Amendment

Amendment to Drawings

FIG. 4

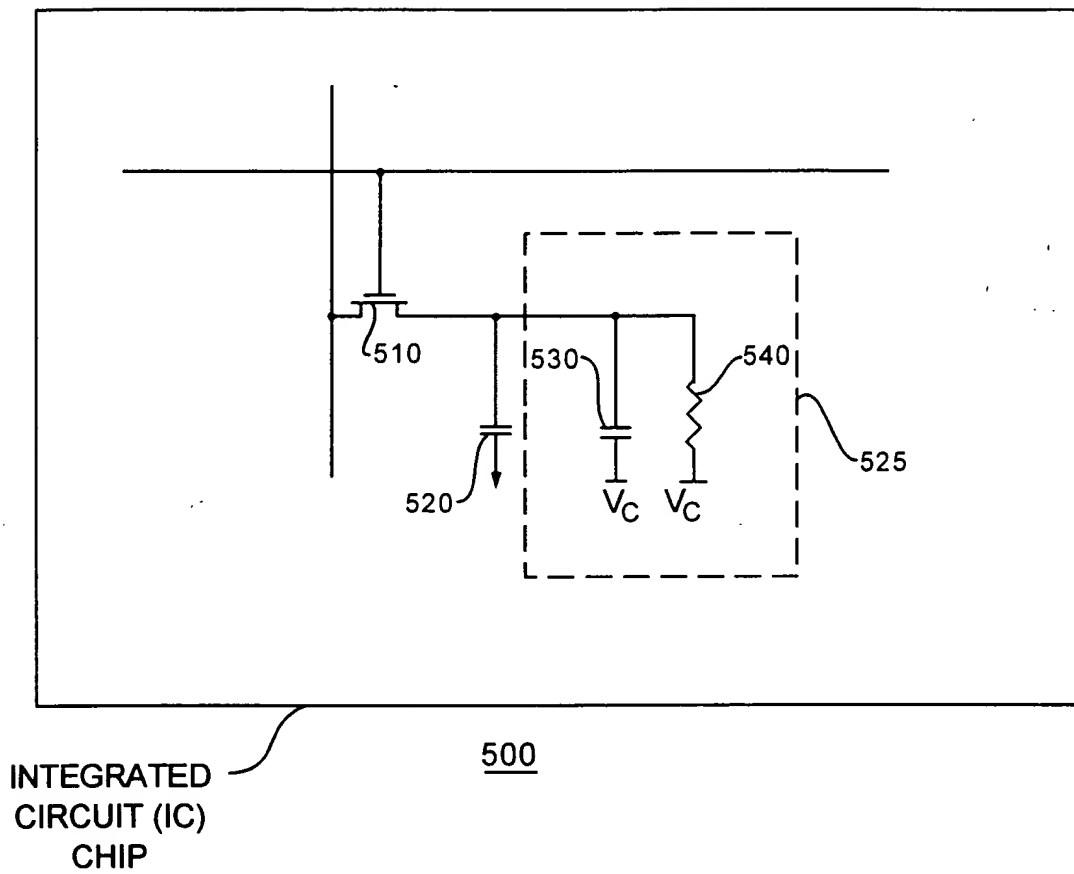
Applicants are enclosing a copy of FIGs. 4 and 7 with red markings to indicate proposed changes to designate the figures as Prior Art as requested by the Office Action

(PRIOR ART)
